STATE OF HAWAII
DEPARTMENT OF TRANSPORTATION
HIGHWAYS DIVISION

INTERSTATE ROUTE H-1
Kunia Interchange Improvements
F. A. I. Project No. 1M-HI-1(219)

Scale: 1"=20' Date: Oct., 1997
SHEET No. L31 OF 52 SHEETS

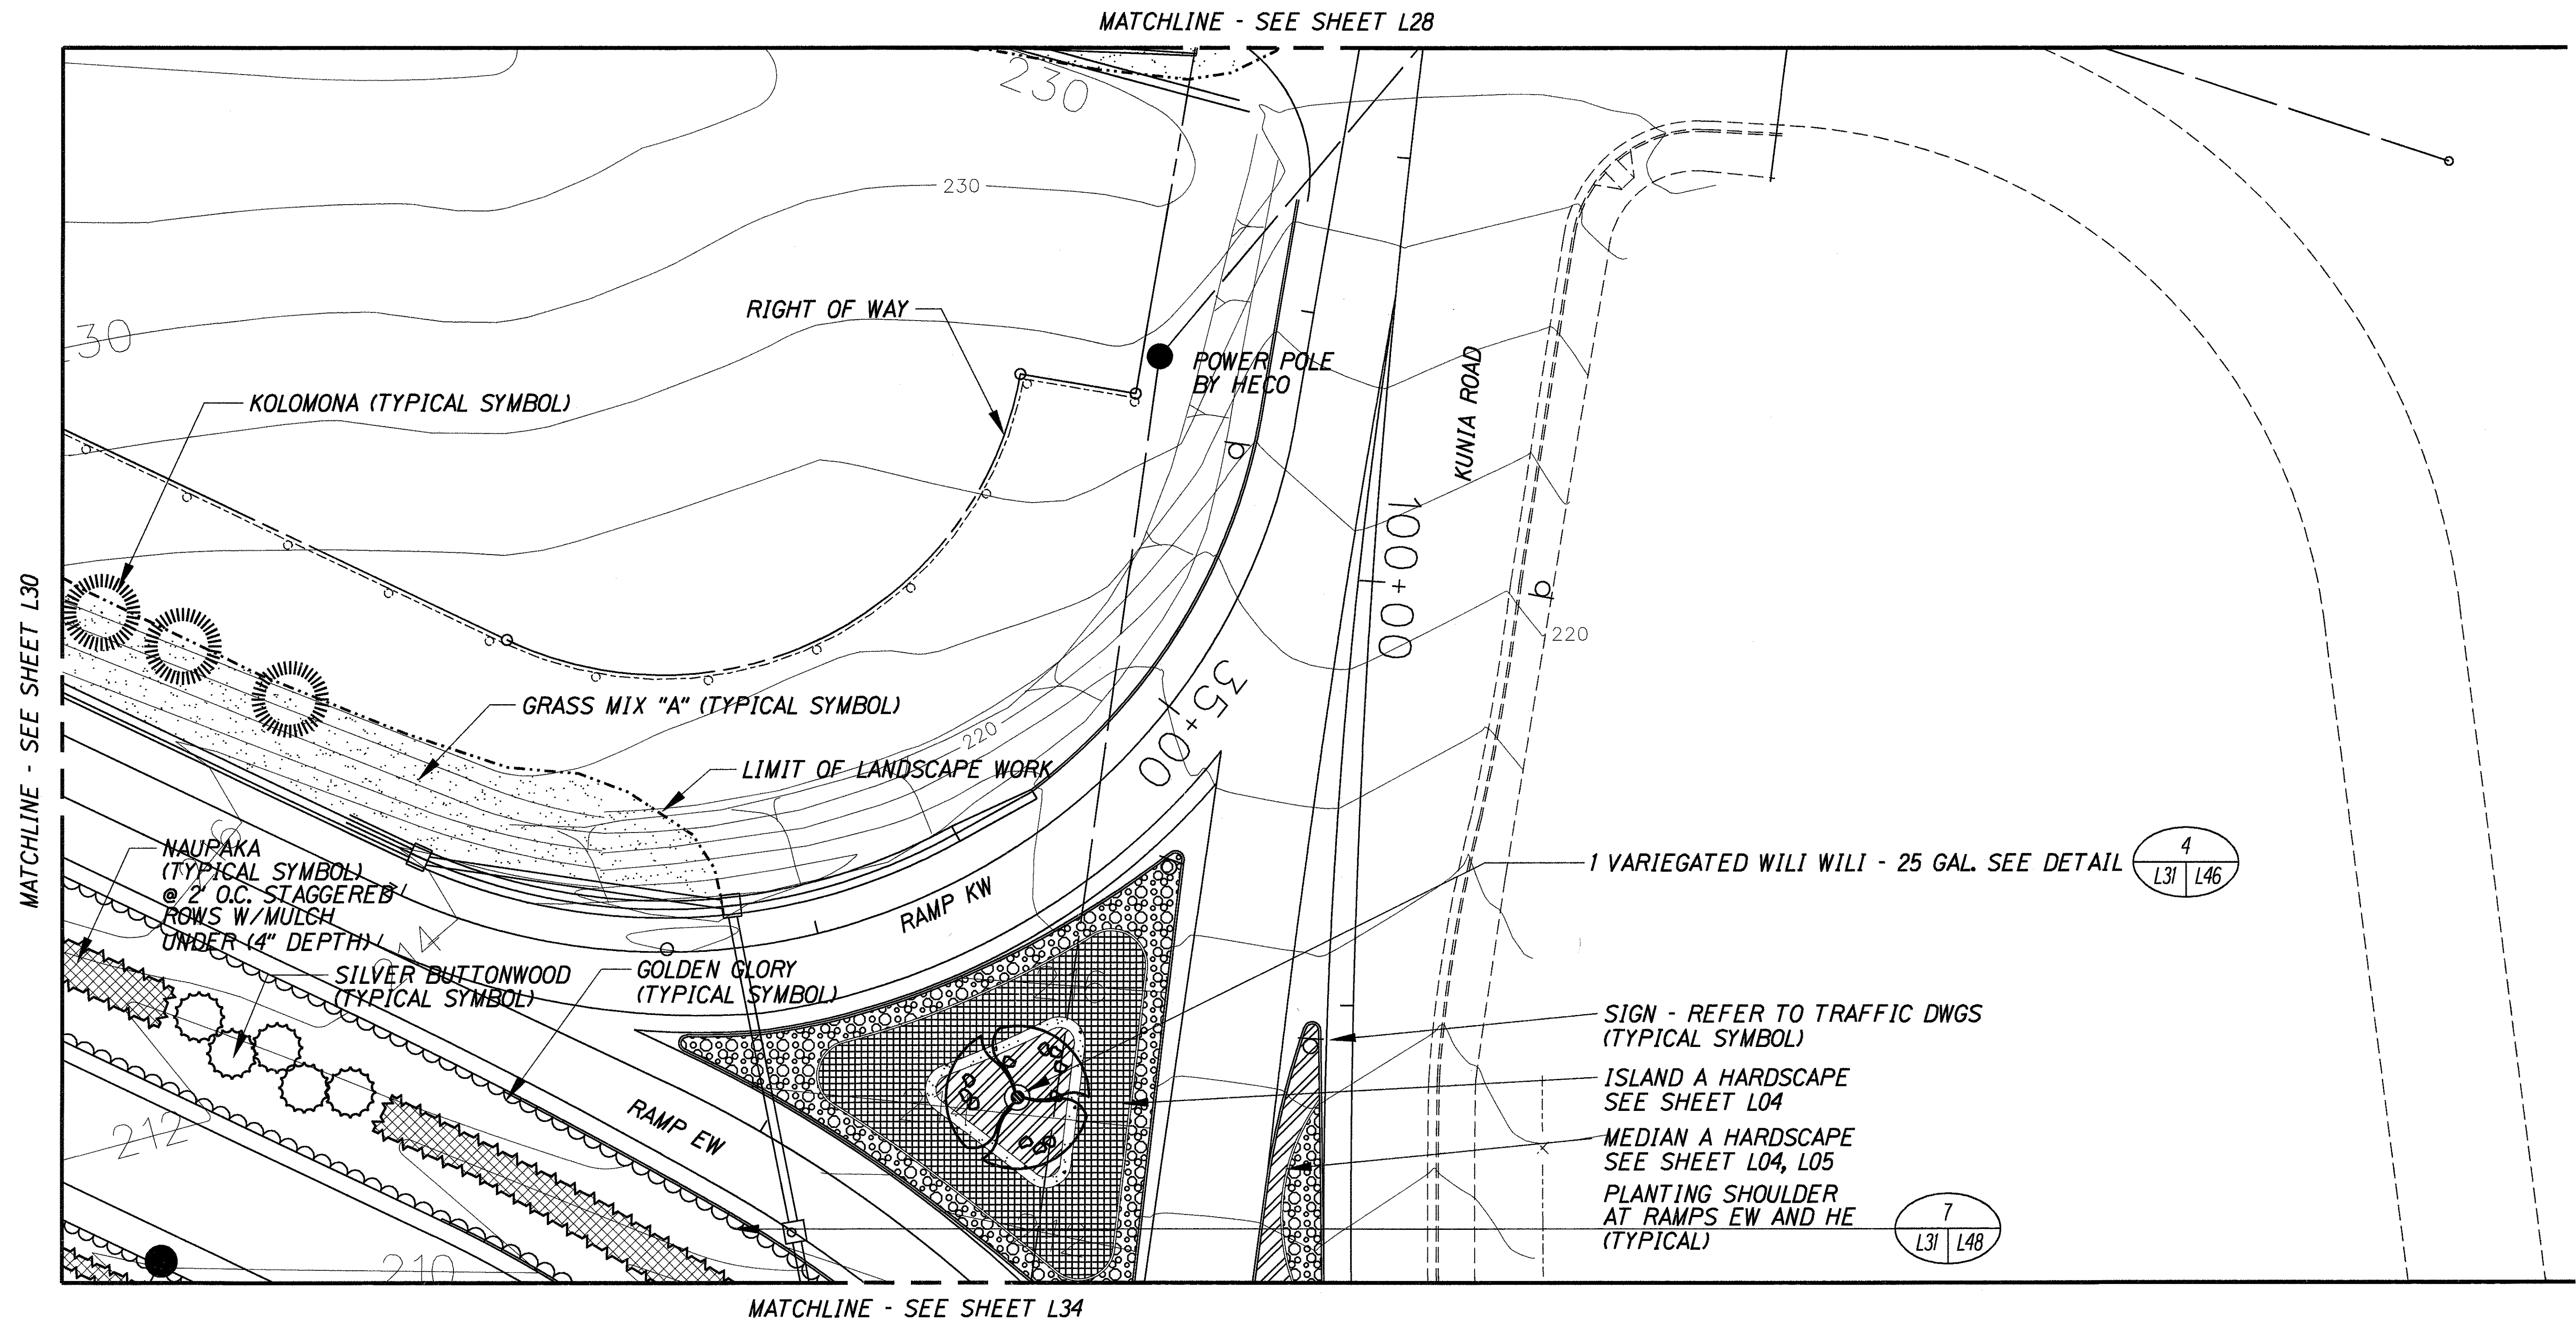
4/3/98	Revised Typical Symbol for Creeping Ilima to Read Golden Glory Per Addendum NO. 3
DATE	REVISION

Scale: 1"=20' Date: Oct., 1997
SHEET No. L32 OF 52 SHEETS

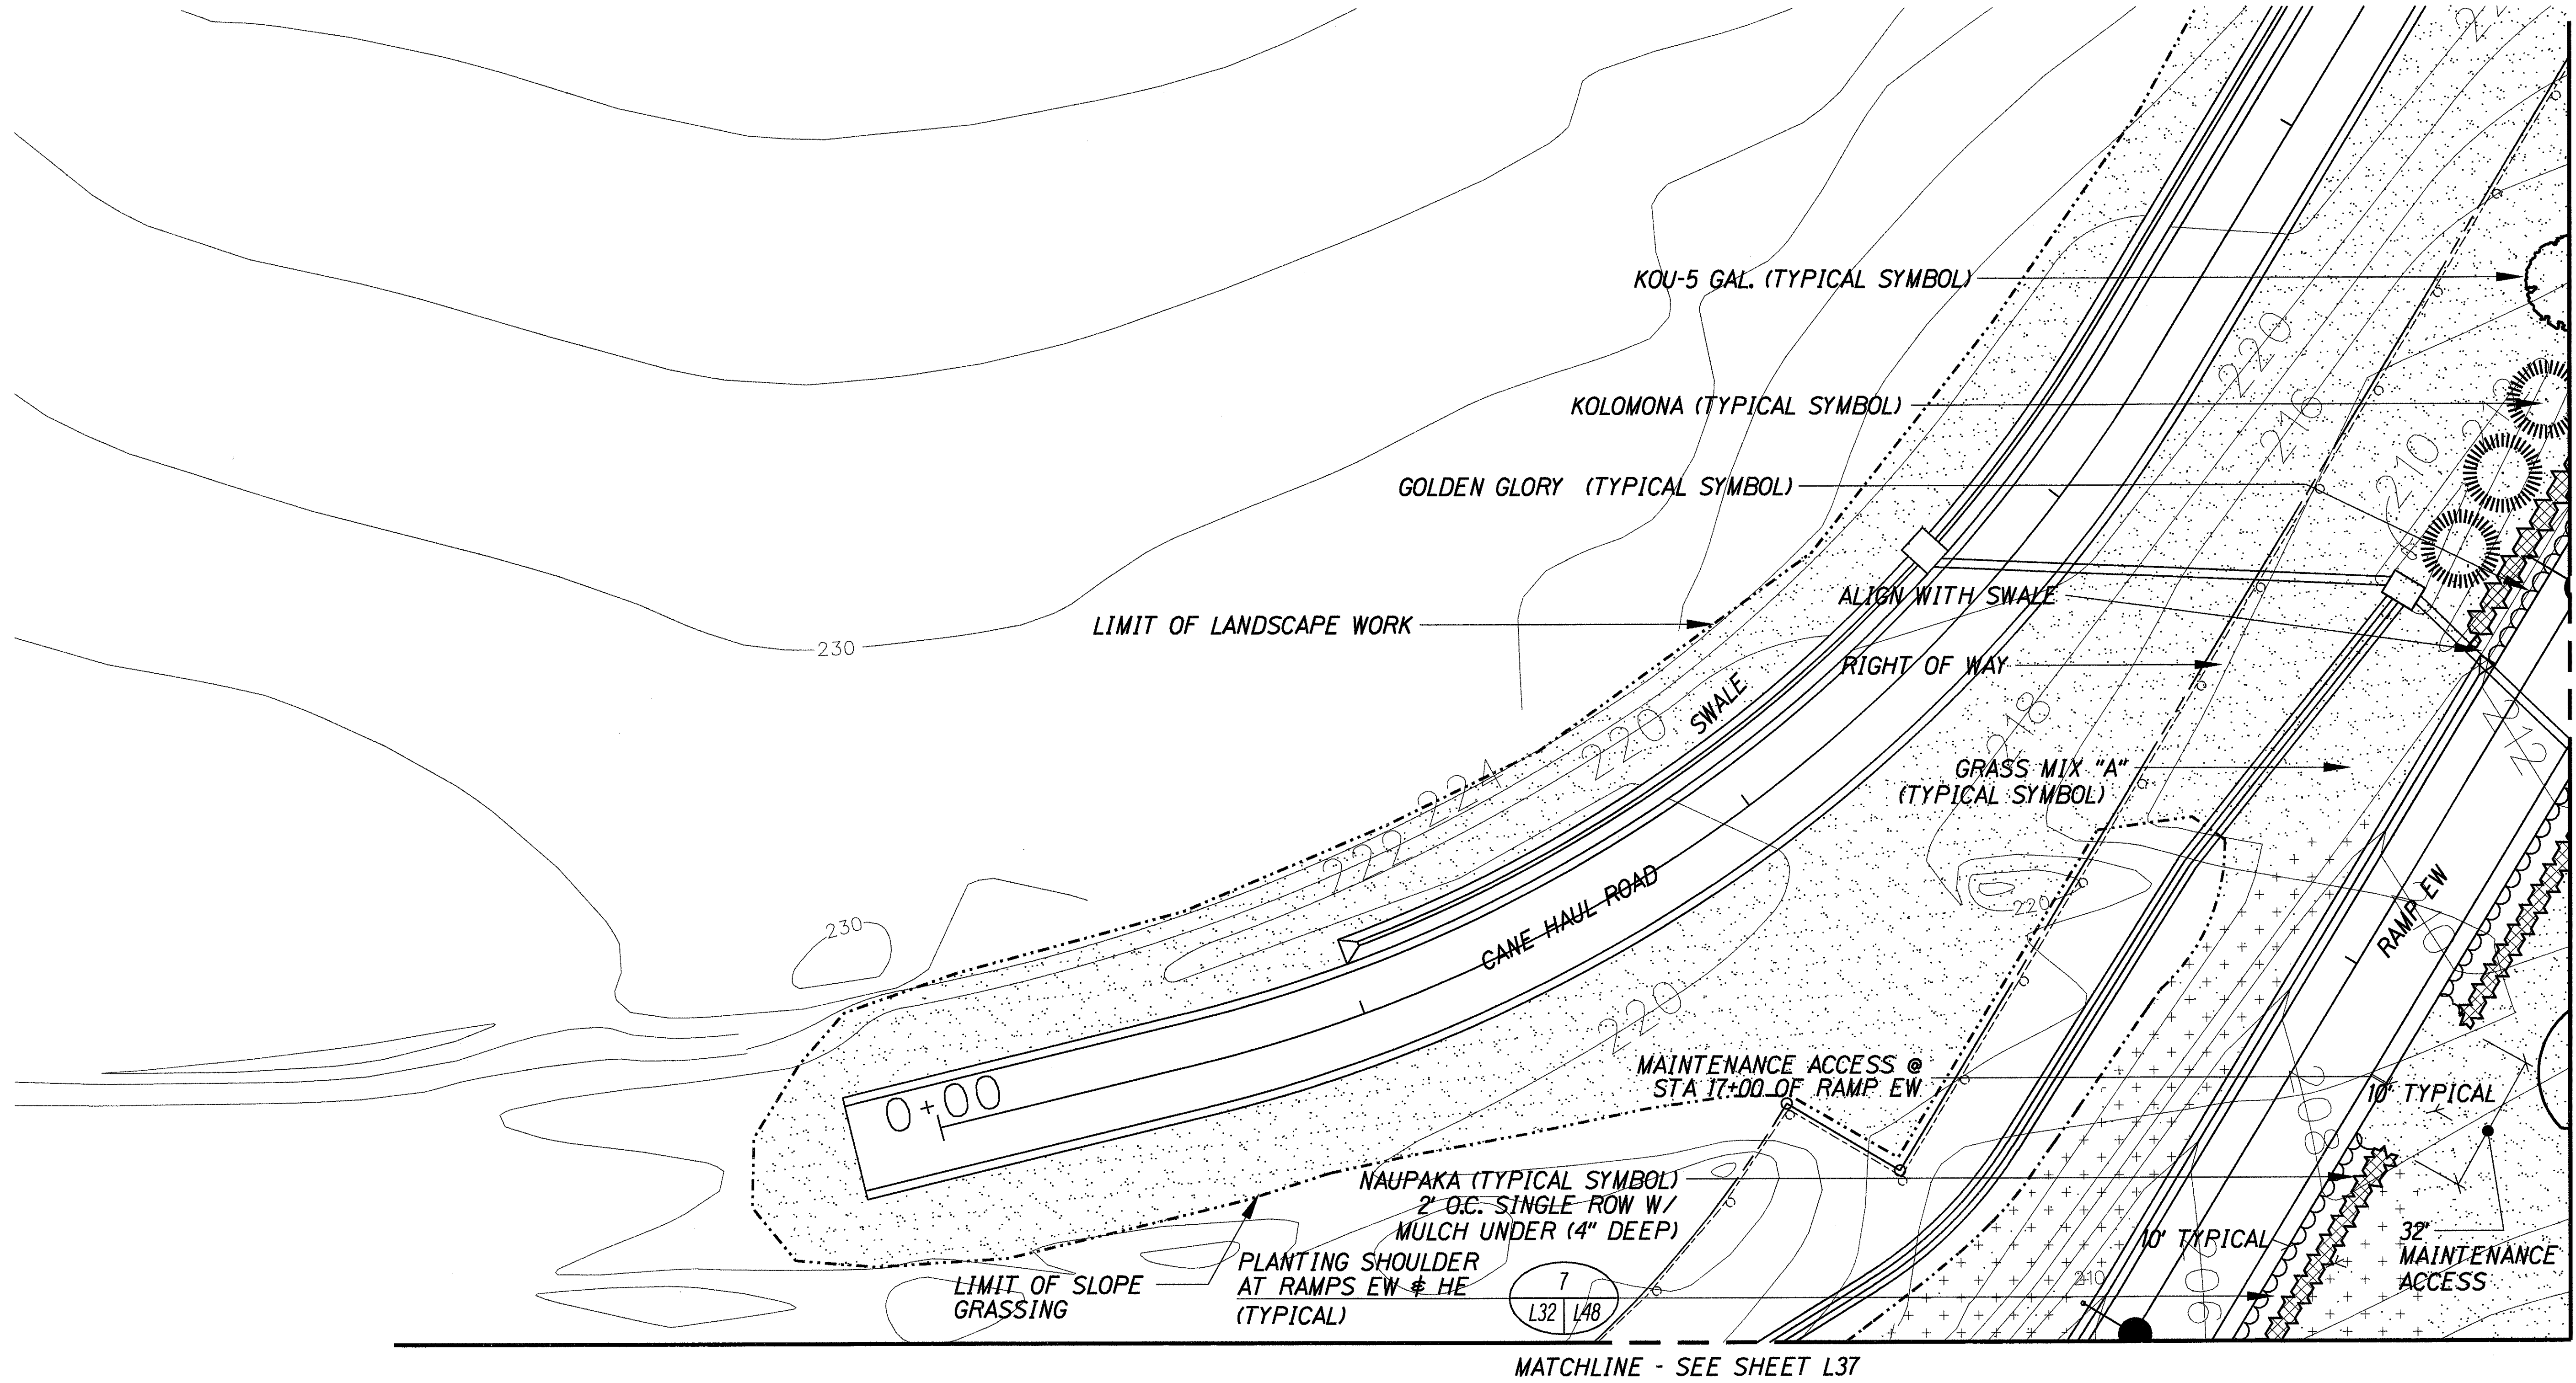
4/3/98	Revised Typical Symbol for Creeping Ilima to Read Golden Glory Per Addendum NO. 3
DATE	REVISION

STATE OF HAWAII DEPARTMENT OF TRANSPORTATION HIGHWAYS DIVISION	
LANDSCAPE PLANTING PLAN	
INTERSTATE ROUTE H-1 Kunia Interchange Improvements F. A. I. Project No. 1M-HI-K(219)	
Scale: 1"=20'	Date: Oct., 1997
SHEET No. L33 OF 52 SHEETS

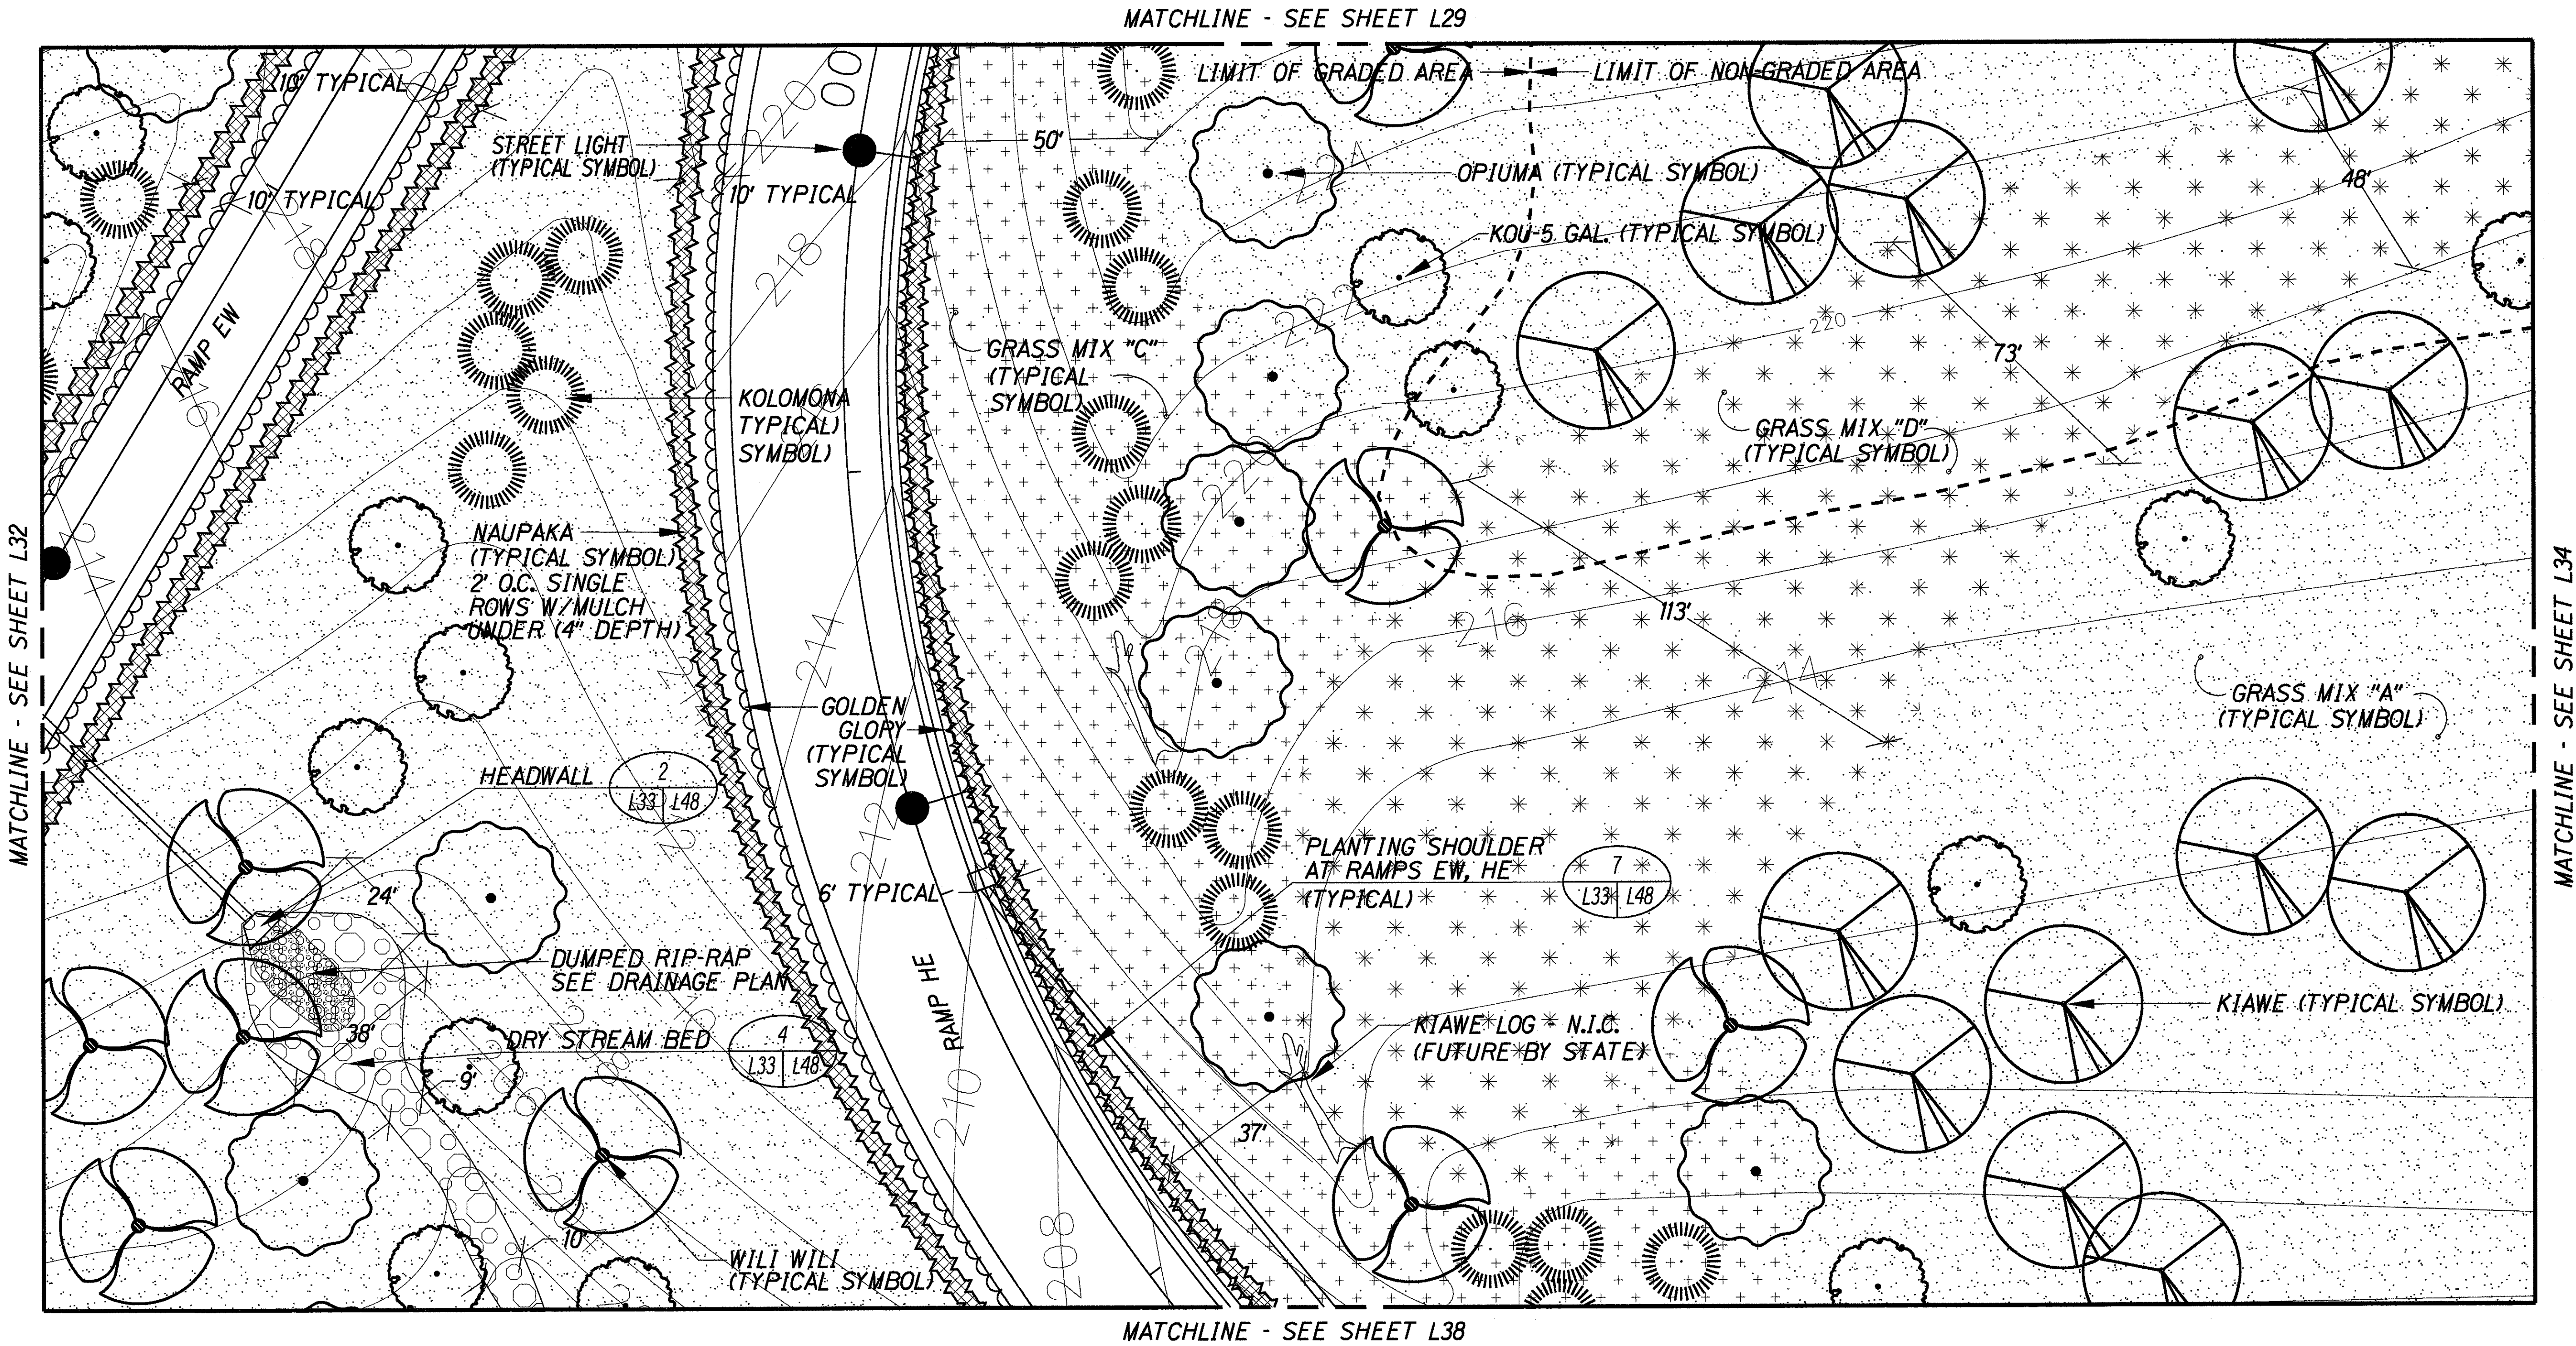
4/3/98	Revised Typical Symbol for Creeping Ilima to Read Golden Glory Per Addendum NO. 3.
DATE	REVISION
